# REGIONAL REVIEW FINDING

**Submitting Local Government:** City of Atlanta  
**Name of Proposal:** Lindbergh MUD

| Preliminary Report: | November 5, 2007 | <b>DEVELOPMENT OF REGIONAL IMPACT<br/>REVIEW REPORT</b> | Project:         | Lindbergh MUD #1590 |

**RE: Development of Regional Impact (DRI) # 1590  
Lindbergh MUD**

## V/C Ratios

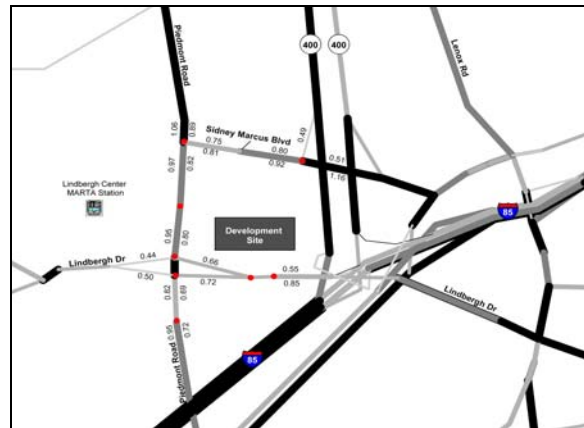
For the V/C ratio graphic, the data is based on 2005, 2010 and 2030 AM/PM peak volume data generated from ARC's 20-county travel demand model utilizing projects from Mobility 2030 and the FY 2006-2011 TIP. The 20-county networks are being used since they consist of the most up to date transportation networks and data. The travel demand model incorporates lane addition improvements and updates to the network as appropriate. As the life of the RTP progresses,

volume and/or V/C ratio data may appear inconsistent due to (1) effect of implementation of nearby new or expanded facilities or (2) impact of socio-economic data on facility types.
